## PCI-SIG ENGINEERING CHANGE NOTICE

<b>TITLE:</b>	CRS Software Visibility + RCRB Header
<b>DATE:</b>	January 21, 2004
<b>AFFECTED DOCUMENTS:</b>	PCI Express Base Specification, Rev 1.0a Root Complex Topology Discovery ECN
<b>SPONSOR:</b>	Carl Jackson; Hewlett-Packard Company Sridhar Muthrasanallur; Intel Corporation

Figure 7-10: PCI Express Capability Structure

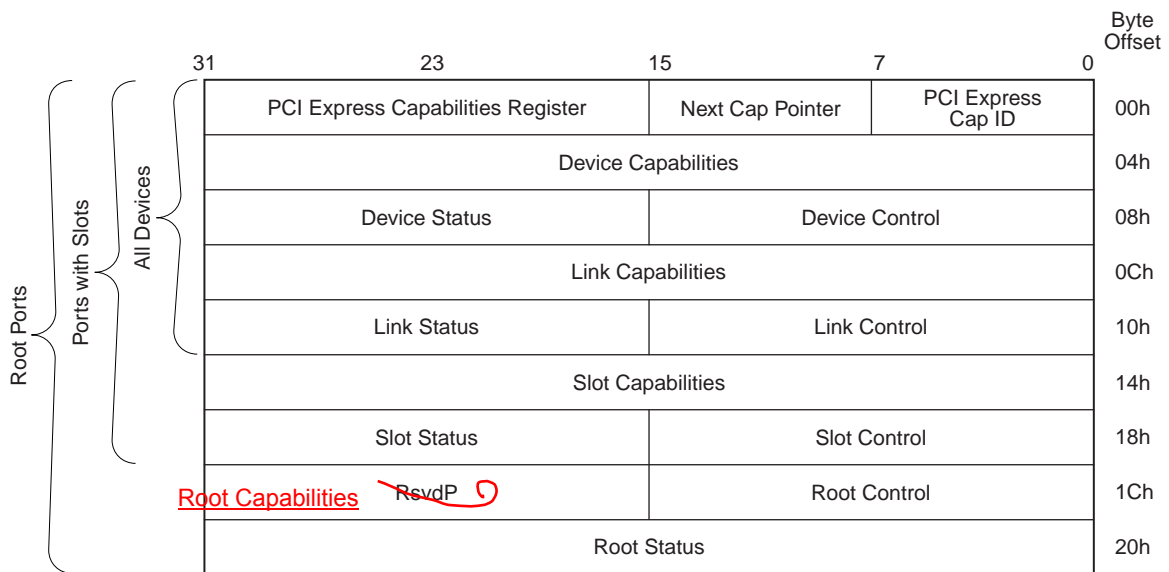
Section 7.8, p. 334 – Modify Figure 7-10 as shown:

**Figure 7-22: Root Control Register**

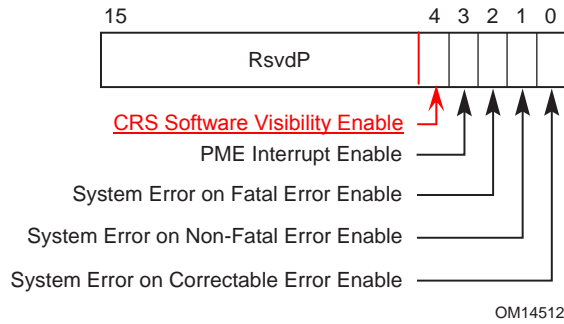
Section 7.8.12, p. 360 – Modify Figure 7-22 as shown:

Bit Location	Register Description	Attributes
<u>4</u>	<u><b>CRS Software Visibility Enable</b> – This bit, when set, enables the Root Port to return Configuration Request Retry Status (CRS) Completion Status to software (see Section 2.3.1). Default value of this field is 0. Root Ports that do not implement this capability must hardwire this bit to 0b.</u>	<u>RW</u>

**Figure 7-b: Root Complex Features Capability Structure**

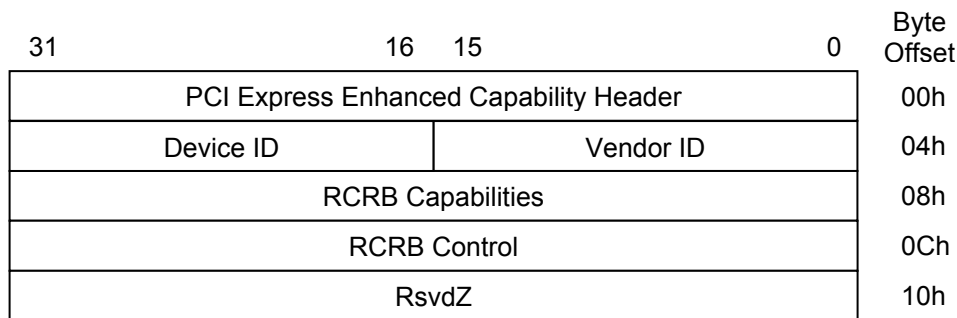
The PCI Express RCRB Header Capability is an optional extended capability that may be implemented in an RCRB to provide a Vendor ID and Device ID for the RCRB and to permit the management of parameters that affect the behavior of Root Complex functionality associated with the RCRB.

Figure 7-60: Link Description Register

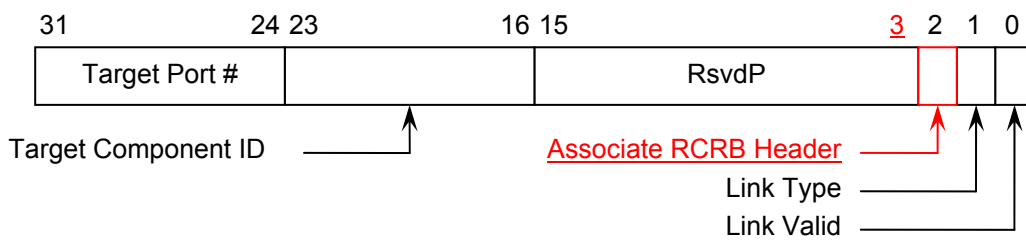
In Section 7.13.3.1 on page 9 of the RC Topology Discovery ECN, modify Figure 7-60 and Table 7-52 as follows:

Bit Location	Register Description	Attributes
0	<b>Link Valid</b> – This field when set to 1 indicates that the Link Entry specifies a valid link. Link entries that do not have <u>either</u> this bit set <u>or the Associate RCRB Header bit set (or both)</u> are ignored by software.	HwInit
1	<b>Link Type</b> – This field indicates the target type of the link and defines the format of the link address field. Defined encodings are: 0 – Link points to memory-mapped space (for RCRB). The link address specifies the 64-bit base address of the target RCRB. 1 – Link points to configuration space (for a Root Port or Root Complex Integrated <b>DeviceEndpoint</b> ). The link address specifies the configuration address (segment, bus, device, function) of the target element.	HwInit
<u>2</u>	<u><b>Associate RCRB Header</b>– This field when set to 1 indicates that the Link Entry associates the declaring element with an RCRB Header Capability in the target RCRB. Link entries that do not have either this bit set or the Link Valid bit set (or both)</u>	<u>HwInit</u>

<p><u>are ignored by software.</u></p> <p><u>The Link Type bit must be 0b when this bit is set.</u></p>	
23:16	<p><b>Target Component ID</b> – This field identifies the Root Complex Component that is targeted by this link entry. A value of 0 is reserved. Component IDs start at 1.</p>	HwInit
31:24	<p><b>Target Port Number</b> – This field specifies the port number associated with the element targeted by the link entry; the target port number is with respect to the Root Complex Component (identified by the Target Component ID) that contains the target element.</p>	HwInit
